PLANNING APPROVAL, PLANNED UNIT DEVELOPMENT & SUBDIVISION STAFF REPORT

NAME Elijah House Subdivision

LOCATION 1867 Duval Street

Date: October 2, 2008

SITE PLAN

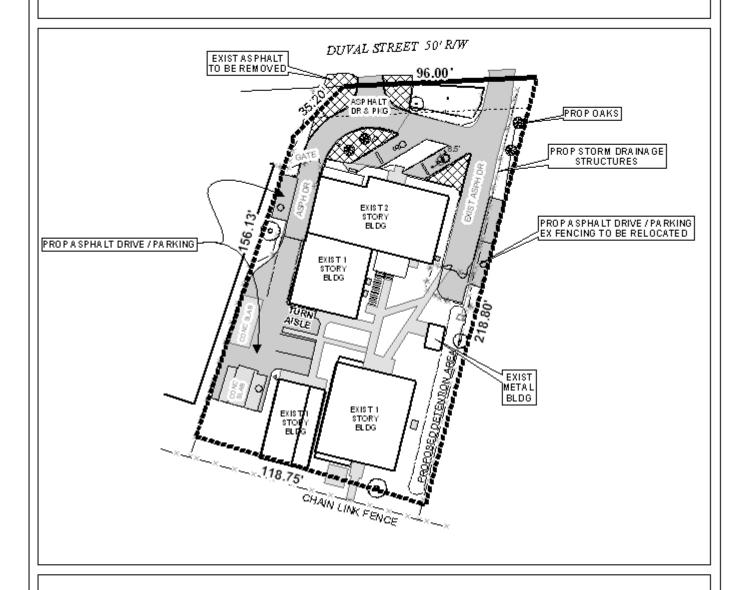
Driveway number, size, location, and design to be approved by Traffic Engineering and conform to AASHTO standards. Final approval for all driveways, proposed and existing will be given upon submittal of final plans. The parking aisle width and internal drives are below city standards. The five parking stalls in the rear of the development on the west side could be brought to standard if the concrete slab is removed or if it is at or below grade. No turn around is shown for the two parallel stalls on the east side of the development. Circulation problems could be solved by extending the drive around the building to allow a one-way drive.

Installation of the proposed asphalt drive and parking space along the West side of the existing structure will require cutting of roots inside the Critical Root Zone of the 48" Live Oak Tree. Due to the negative impact to the Critical Root Zone of 48" Live Oak Tree Urban Forestry is not in favor of the installation of the proposed asphalt drive and parking space.

The site fronts onto Duval Street, a proposed major street. The existing right-of-way width for Duval Street is 50 feet, but as a major street, the right-of-way width should be 80 feet, according to the Major Street Plan component of the Comprehensive Plan. Sufficient right-of-way should be dedicated along Duval Street to provide 40-feet, as measured from the centerline of Duval Street, and is shown on the site plan and plat.

The existing facility provides 40 beds, and is proposing to provide 10 marked parking spaces on the site. The Zoning Ordinance does not clearly delineate the requirements for parking for a

The tree and landscape plan provided with the application shows existing and proposed trees and landscape areas. One of the existing trees crosses a property line, thus only half credit can be given for that tree. Another tree will be impacted by the proposed storm water detention area, thus that tree cannot be counted for credit. The existing live oak on the West side will be impacted by the proposed parking expansion, however, if only 4 parking spaces are required, access on this side can potentially be eliminated. Due to the half credit and no credit tree issues mentioned, five (5) new trees must be added on site, all of which may be understory trees. The site plan should be revised to show additional trees.

No dumpster is depicted on the site plan. If a dumpster is used, it must be depicted on the site plan, or a statement must be placed on the site plan indicating that no dumpster is used.

- 1) Revision of the site plan to show only 4 parking spaces, meeting AASHTO design requirements to the greatest extent feasible, and to address Traffic Engineering and Urban Forestry comments contained within the Staff Report;
- 2) Depiction of concrete wheel stops or curbing to ensure that vehicles will not encroach upon any required landscape areas or adjacent property;

- 3) Revision of the site plan to provide 5 additional understory trees;
- 4) Revision of the site plan to depict and label a 6-foot high wooden privacy fence along the rear of the property where it abuts Baumhauer Park; and
- 5) Revision of the site plan to depict a dumpster, or the addition of a note stating that no dumpster is used.

- 1) Revision of the site plan to show only 4 parking spaces, meeting AASHTO design requirements to the greatest extent feasible, and to address Traffic Engineering and Urban Forestry comments contained within the Staff Report;
- 2) Depiction of concrete wheel stops or curbing to ensure that vehicles will not encroach upon any required landscape areas or adjacent property;
- 3) Revision of the site plan to provide 5 additional understory trees;
- 4) Revision of the site plan to depict and label a 6-foot high wooden privacy fence along the rear of the property where it abuts Baumhauer Park; and
- 5) Revision of the site plan to depict a dumpster, or the addition of a note stating that no dumpster is used.
